AGENDA CITY OF LAKE WORTH BEACH HISTORIC RESOURCES PRESERVATION BOARD REGULAR MEETING CITY HALL COMMISSION CHAMBER WEDNESDAY, SEPTEMBER 08, 2021 -- 6:00 PM

MEMORANDUM DATE:	September 1, 2021
AGENDA DATE:	September 8, 2021
TO:	Chair and Members of the Historic Resources Preservation Board
RE:	732 North Palmway Continuance
FROM:	Jordan Hodges, Senior Preservation Coordinator Abraham Fogel, Preservation Planner Department for Community Sustainability

MEMORANDUM DATE:	September 1, 2021
AGENDA DATE:	September 8, 2021
TO:	Chair and Members of the Historic Resources Preservation Board
RE:	732 North Palmway
FROM:	Jordan Hodges, Senior Preservation Coordinator Abraham Fogel, Preservation Planner Department for Community Sustainability

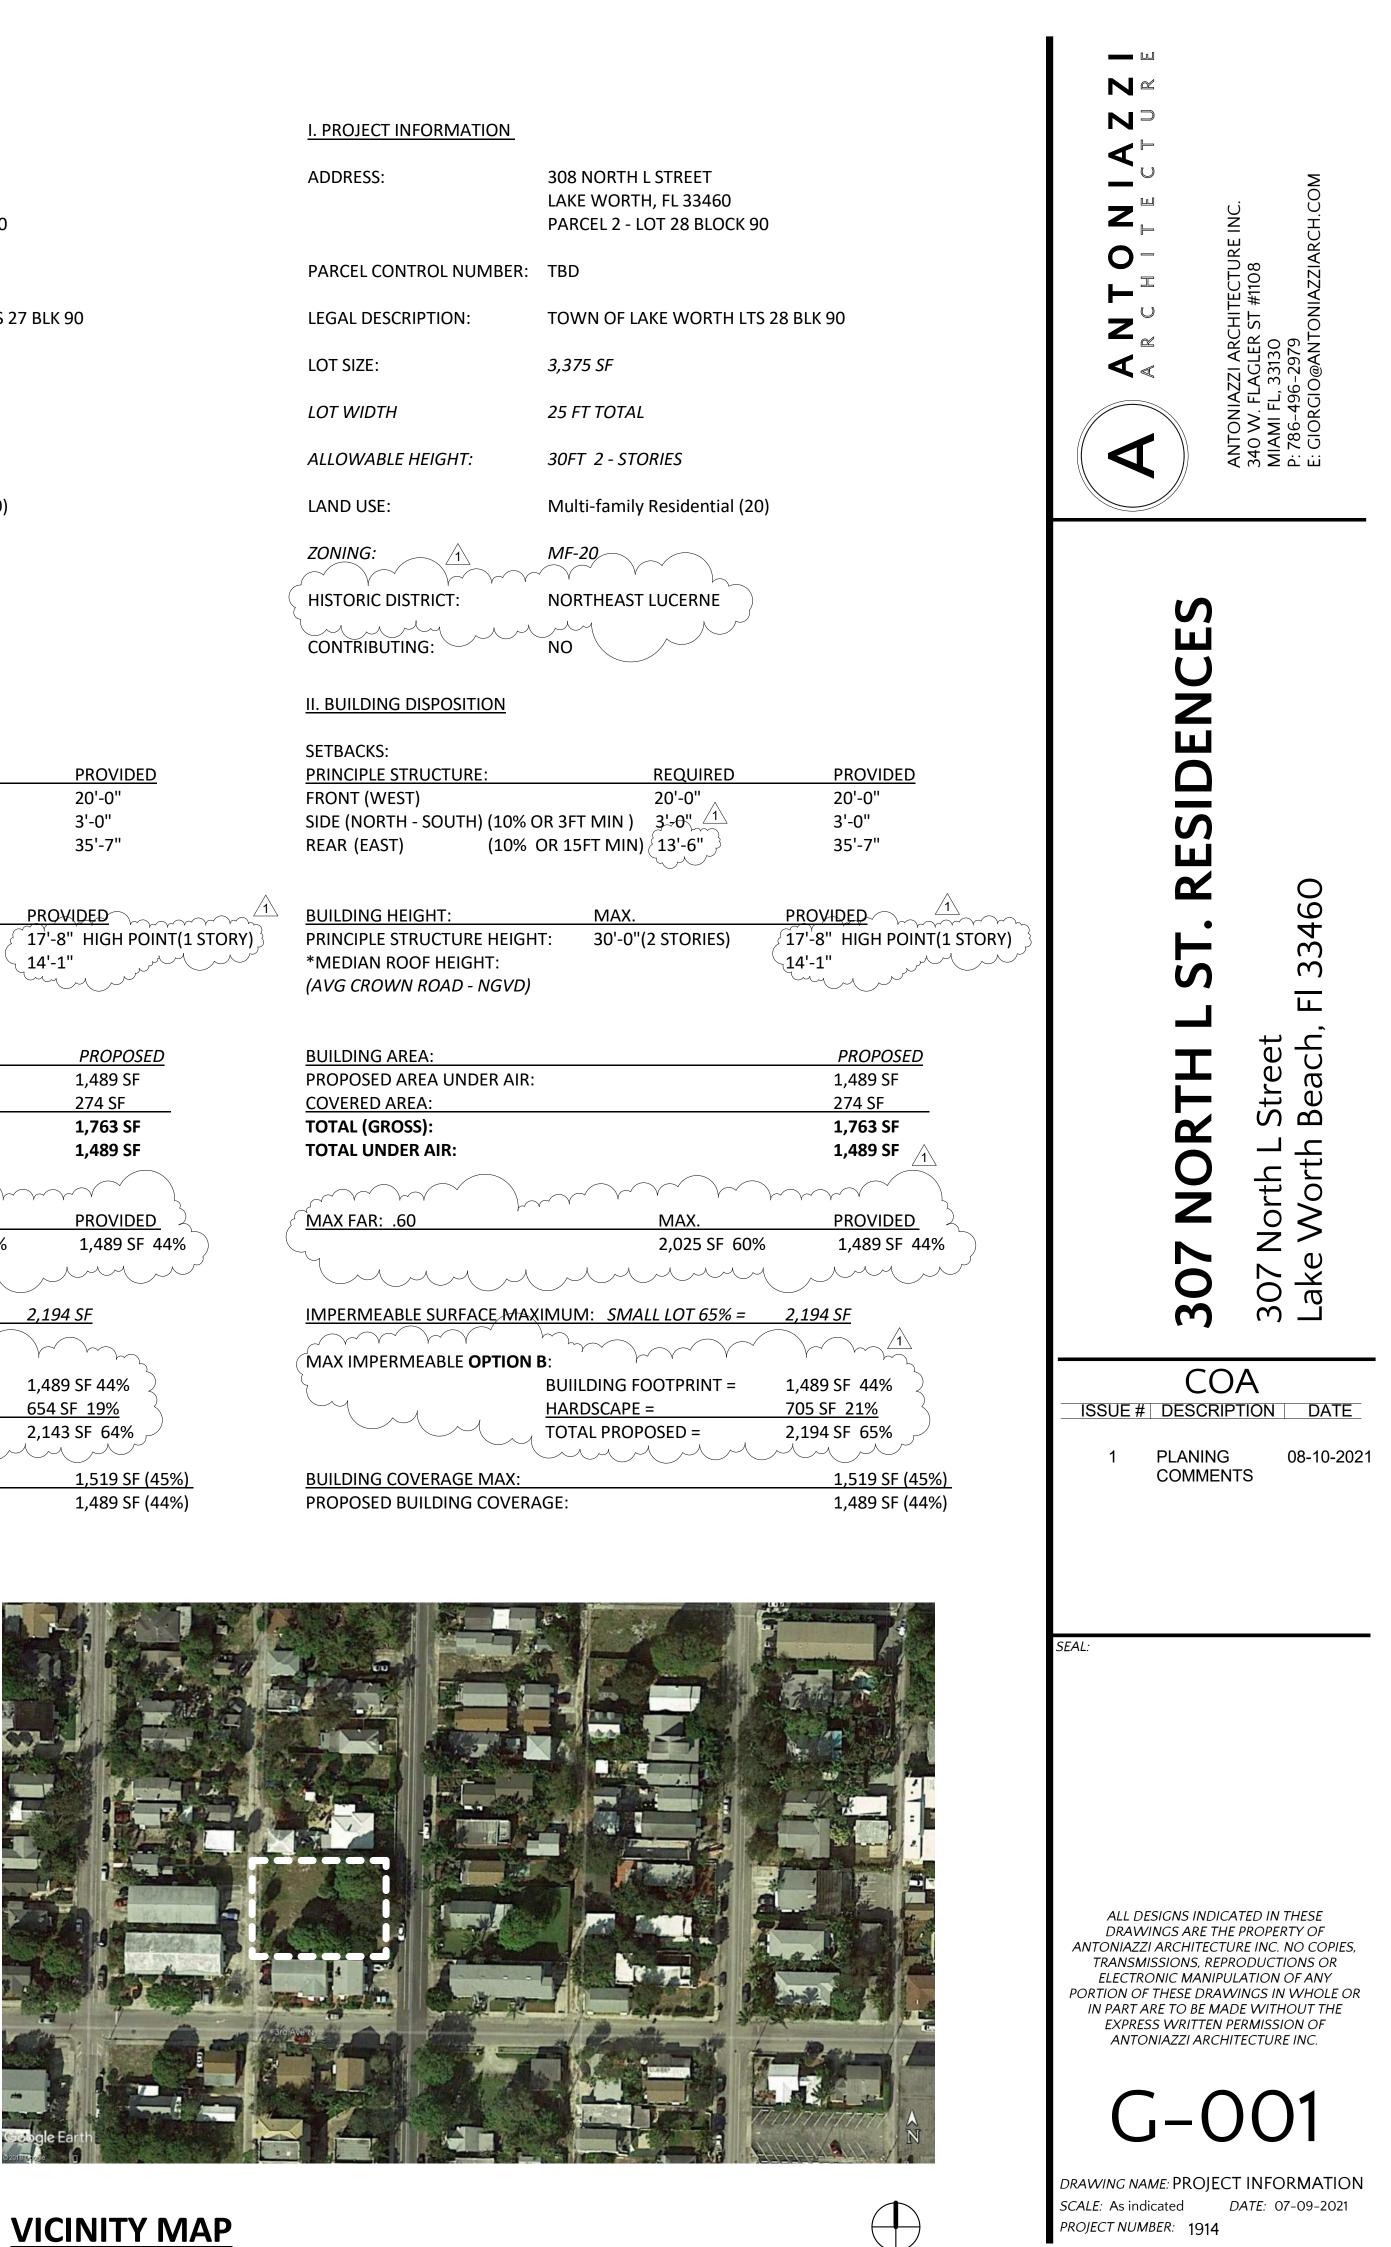
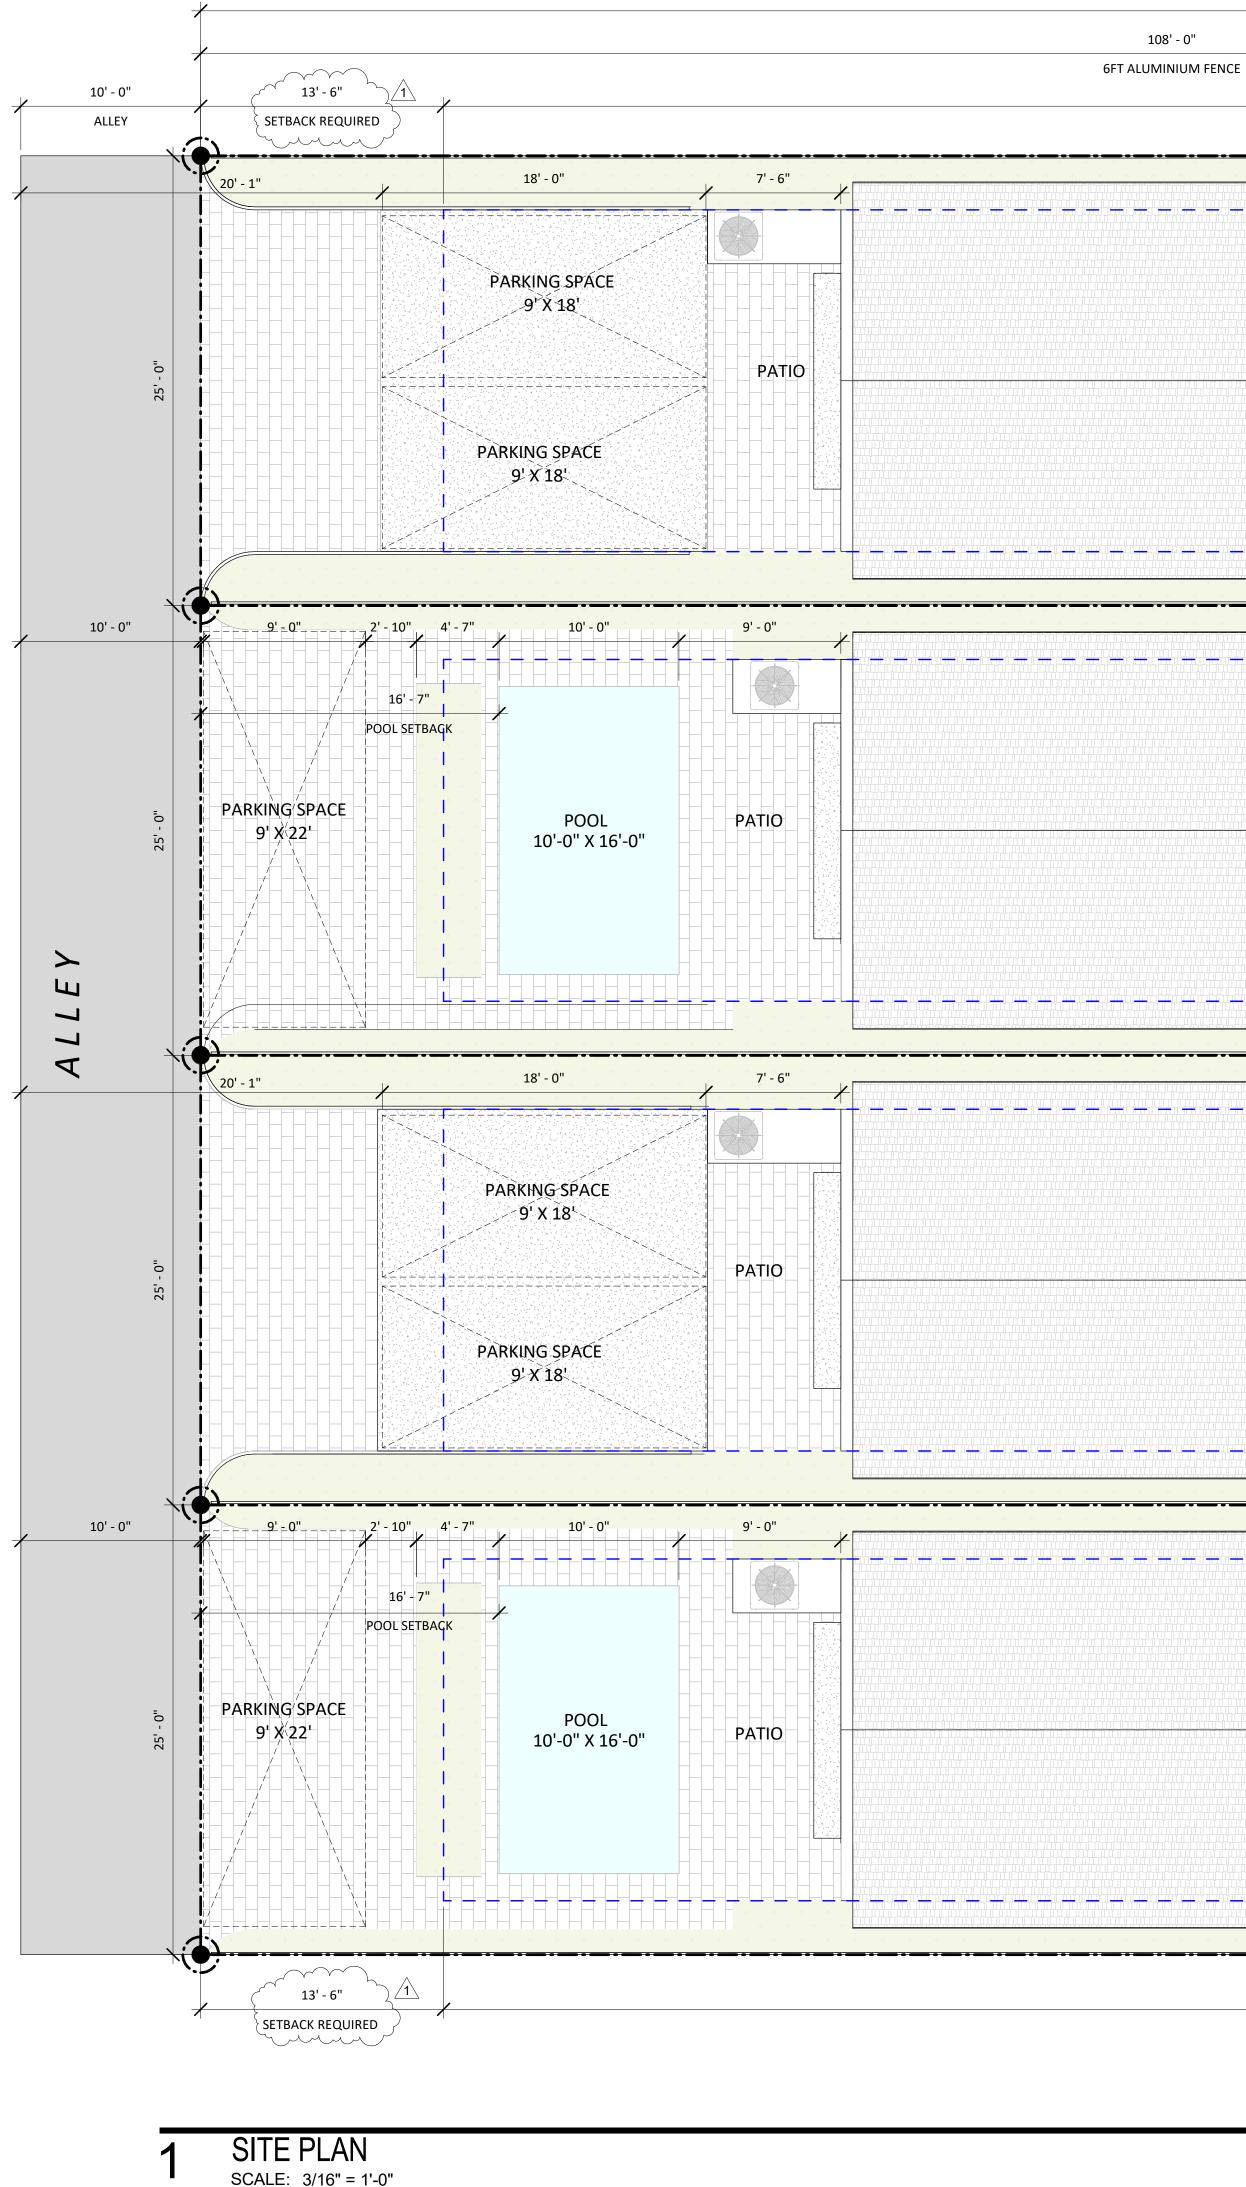
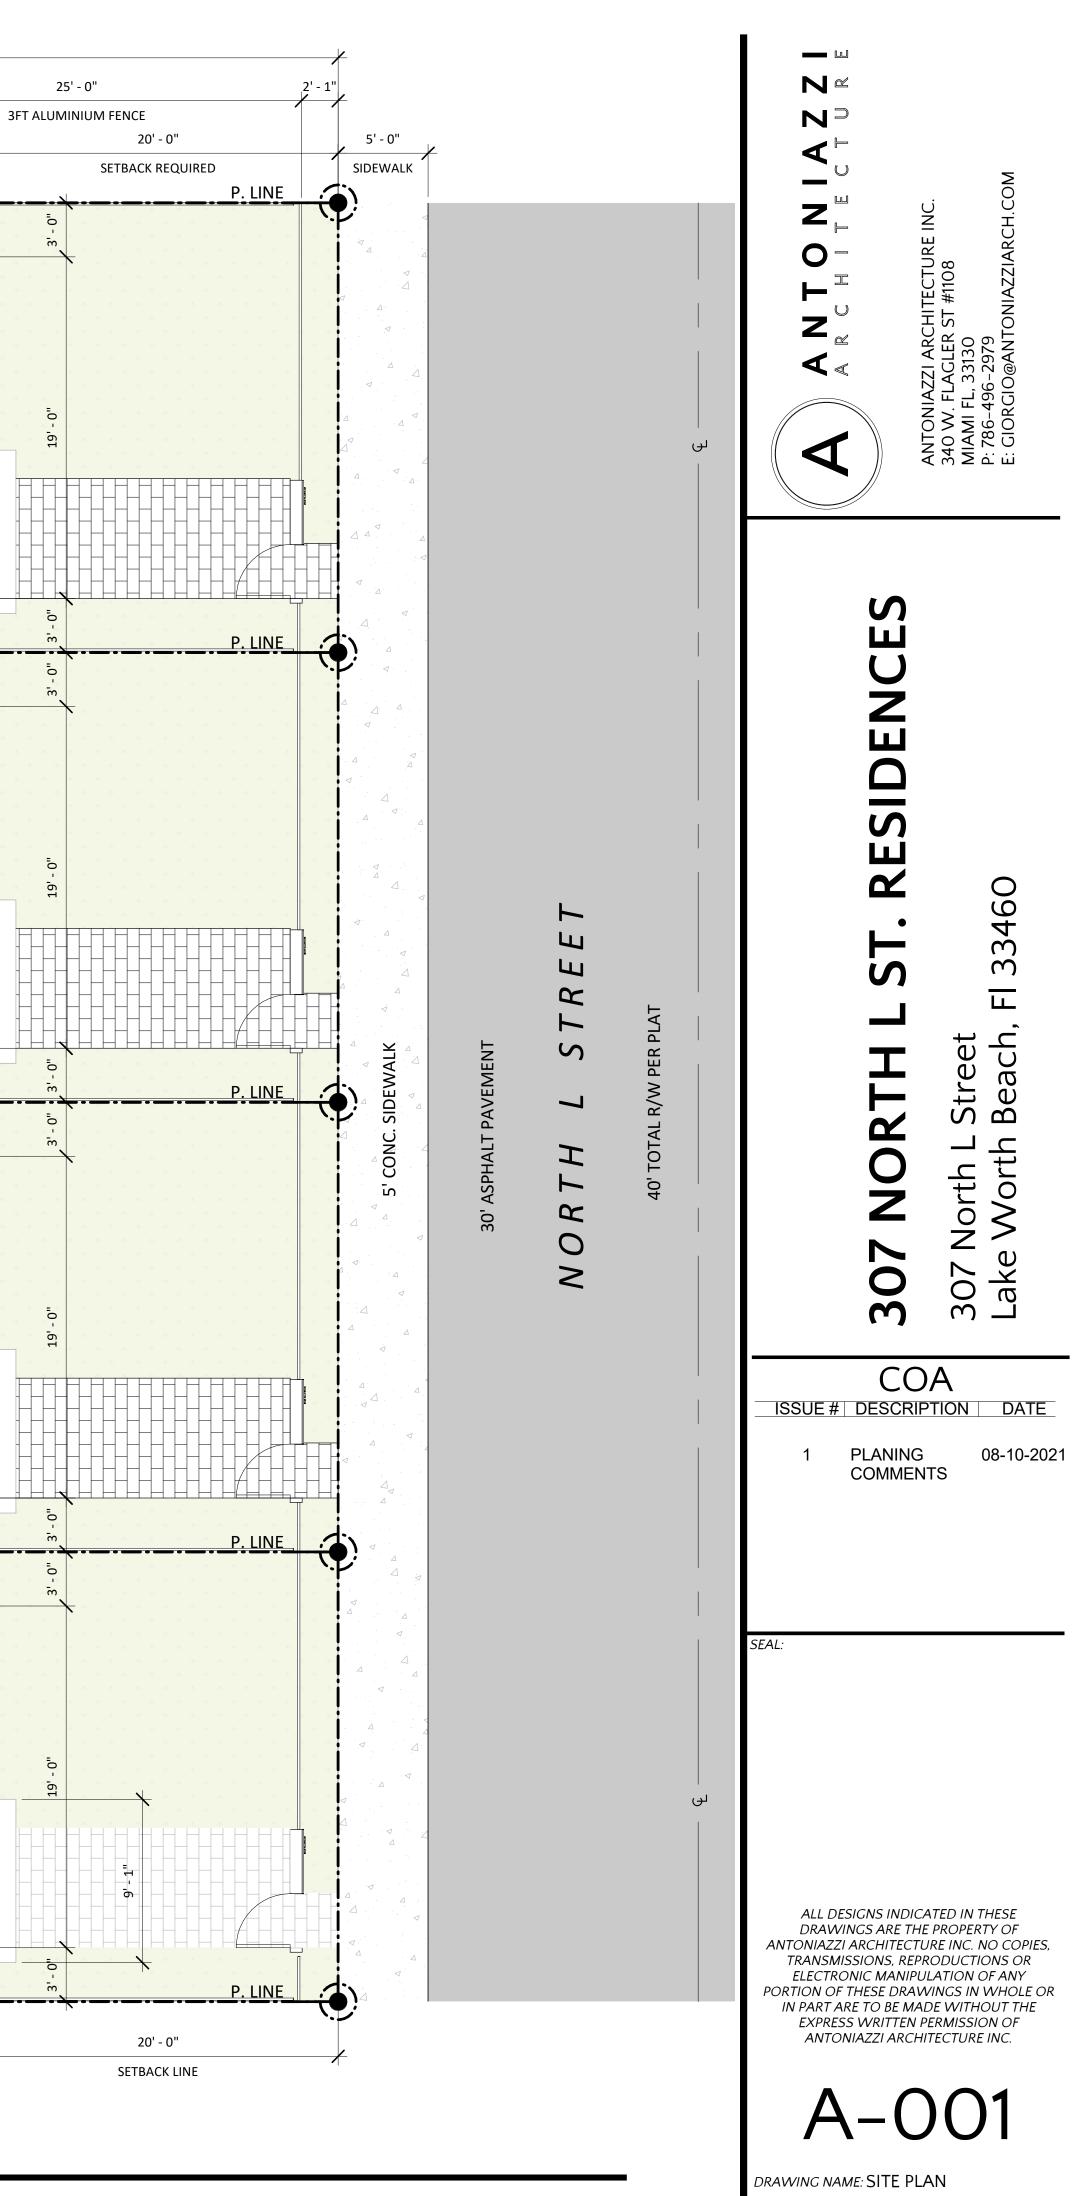
- 1) Move FAR from Project Information to Building Disposition and provide calculations. *Response:* Note provided. See sheet G-001
- 2) Max Far is provided at .50, whereas .60 is allowed for lots up to 4,999 sq. ft. *Response:* Information updated. See sheet G-001

1) Front porch slab/stairs shall not encroach into front 20'-0" front setback. Please revise. *Response:* The slab/stair has been removed. See sheet A-100

1) The minimum required rear setback is 13'-6" (10% of lot depth). *Response:* Rear setback updated to 13'-6". See sheet A-001
